NOTICE OF DECISION

ADMINISTRATIVE SITE DEVELOPMENT PERMIT GILMAN POINT

APPLICATION NO: ASDP15-00002

Project name: Gilman Point

PRELIMINARY
TREE PLAN
L1.1

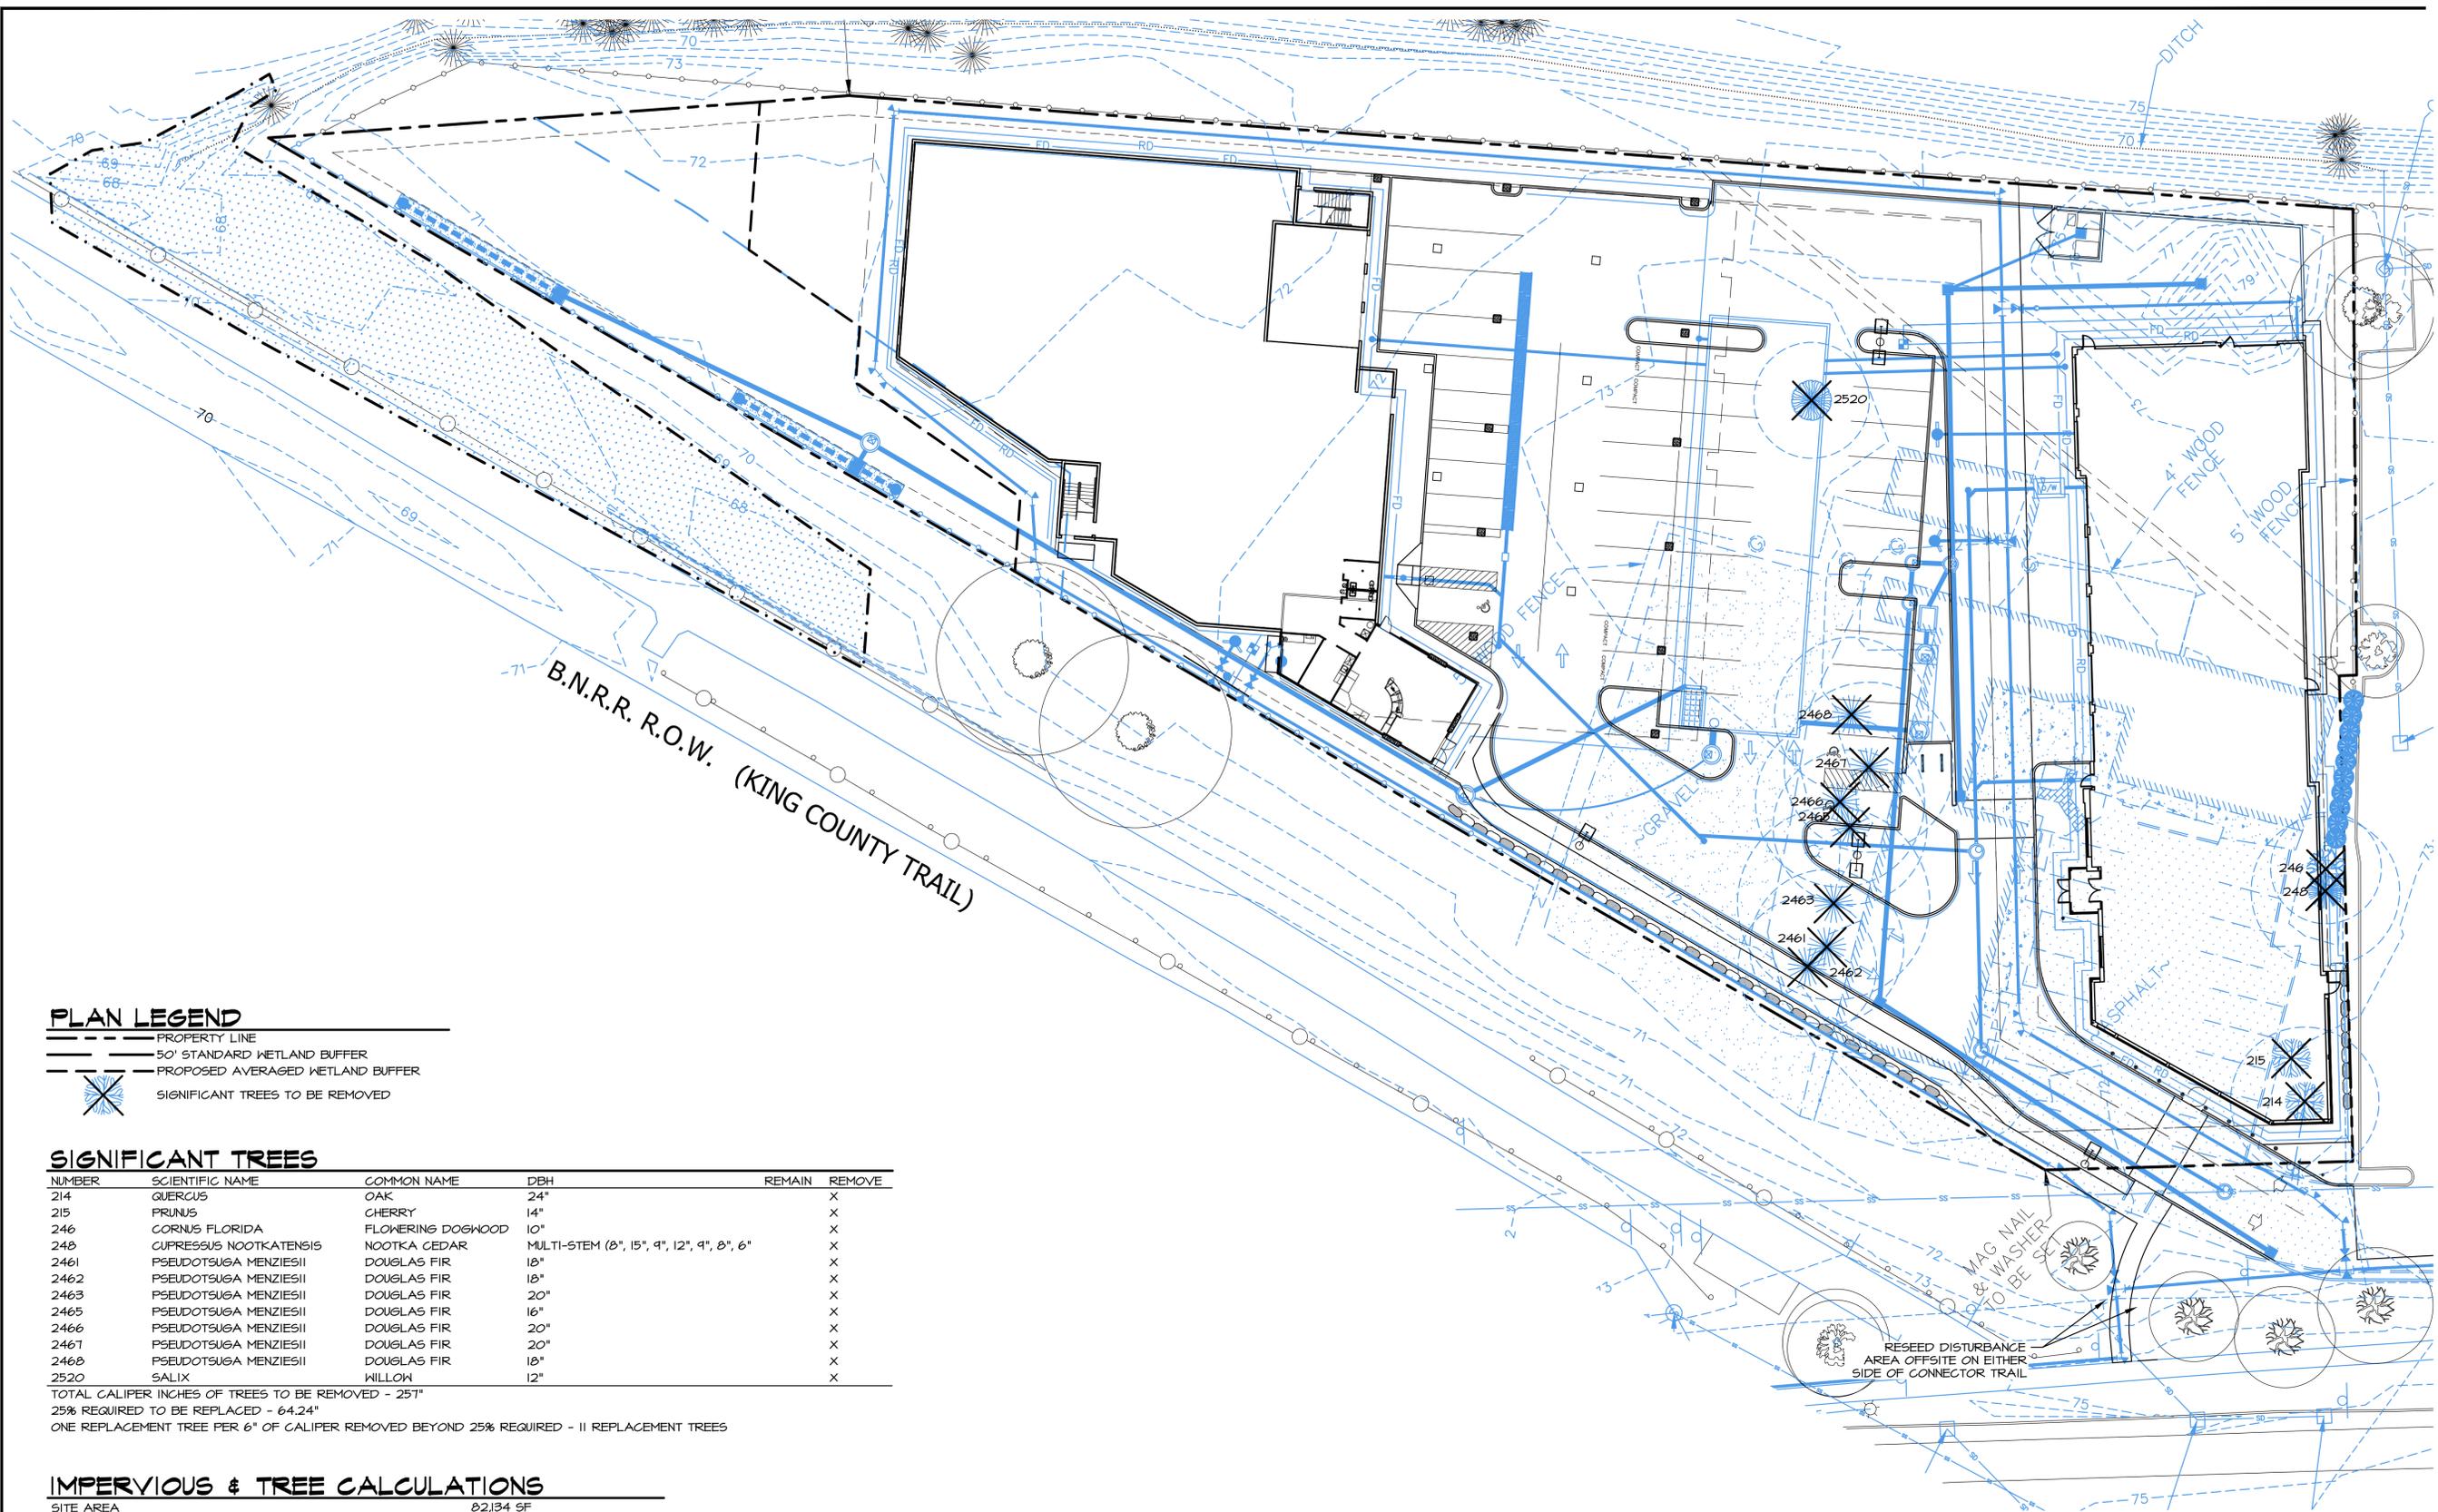
10.12	Tree Removal	X				This section is applicable to existing developments. It does not apply to new development.	
10.13	Tree Retention			X	X	Sheet L1.1 shows that 12 significant trees are present on the site and have an aggregate diameter (dbh) of 257 inches. The requirement states that 25 percent of the total dbh of trees must be retained (64" dbh).

CIDDS Standard #	Name	Not Appl.	Meets Standard?		Review At Constn.	Staff Analysis	Conditions of Approval
			Yes	No			
						<p>Based upon the location of the existing trees, all of the trees are proposed to be removed and therefore Section 10.13.B (Modification of Tree Retention Requirements) is applicable. The proposal to remove the tree is consistent with the criteria for a reduction of the tree retention requirements as follows:</p> <ol style="list-style-type: none"> 1. The modification is consistent with the purpose and intent of the Landscape chapter and the Central Issaquah Plan goals and policies. 2. The modification does not retain the retention of groupings of smaller trees as such groupings do not exist on the property. As a result, compliance with this requirement is not possible for this property. A large grouping 11 replacement evergreen trees will be provided to create the grouping of trees that is intended by this criteria. 3. The modification is necessary because the shape and location of the subject property may jeopardize reasonable use of the property and reasonable alternatives do not exist. 4. The modification is necessary to allow for site features including: buildings, utilities, storm drainage, circulation facilities, etc. 5. Not applicable. 6. The applicant will be required to provide trees on or off-site or pay a fee-in-lieu of to the City Tree Fund per Sections 10.14.C-D of the CIDDS. See Section 10.14 and Condition 15.

PRELIMINARY
LANDSCAPE PLAN
L1.2

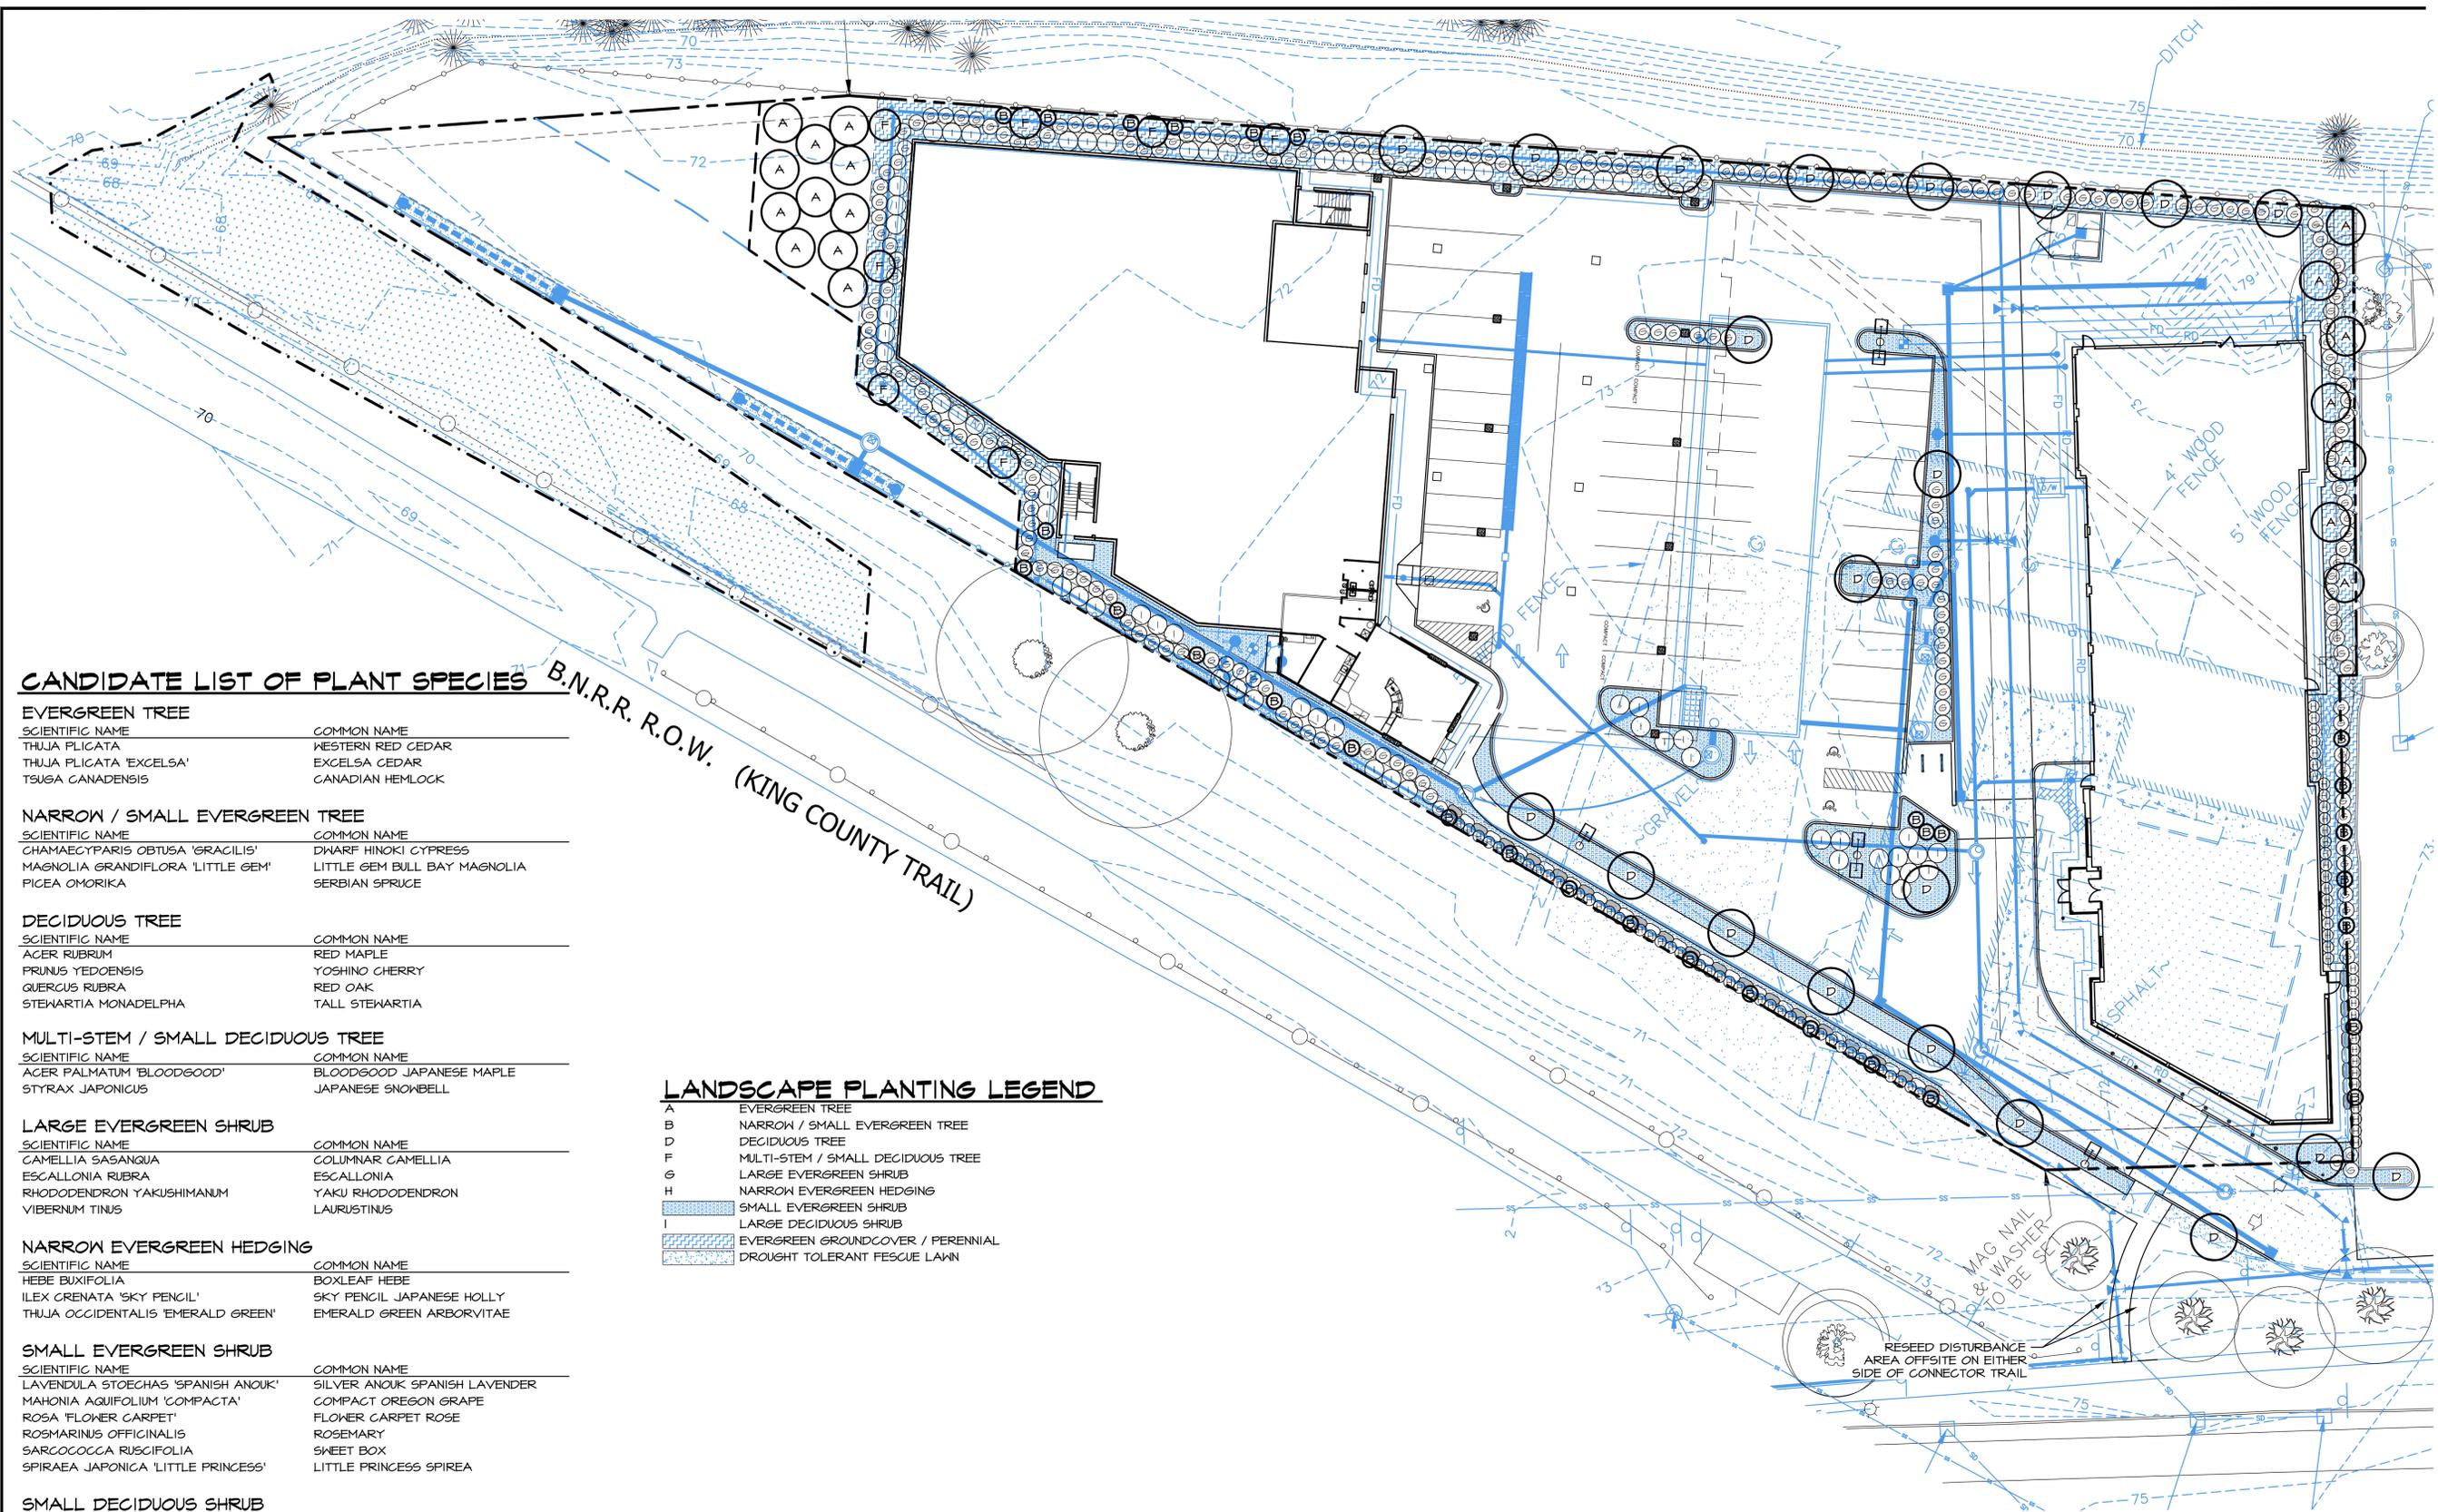
12.6.I	Incorporate annual and colorful plantings		X		X	A variety of colors and textures of planting materials are proposed; however, no annuals are provided. (See sheet L1.2).

CIDDS Standard #	Name	Not Appl.	Meets Standard?		Review At Constn.	Staff Analysis	Conditions of Approval
			Yes	No			
10.4.A.3	Edge Landscape		X		X	Edge landscaping is shown on Sheet L1.2. Plant details and specifications will be verified with the Landscape permit to ensure that the desired edge landscaping treatment is achieved.

11.3.C	Emphasize Landscaping		X		X	<p>A concept landscape plan has been provided with this application; see Attachment 6, Sheet L1.2. In general, the plans show sufficient landscape coverage and planting variety. Landscaping is not reviewed at a technical level with the ASDP review and detailed review will occur with the Landscape Permit to ensure compliance with the Development and Design Standards.</p>
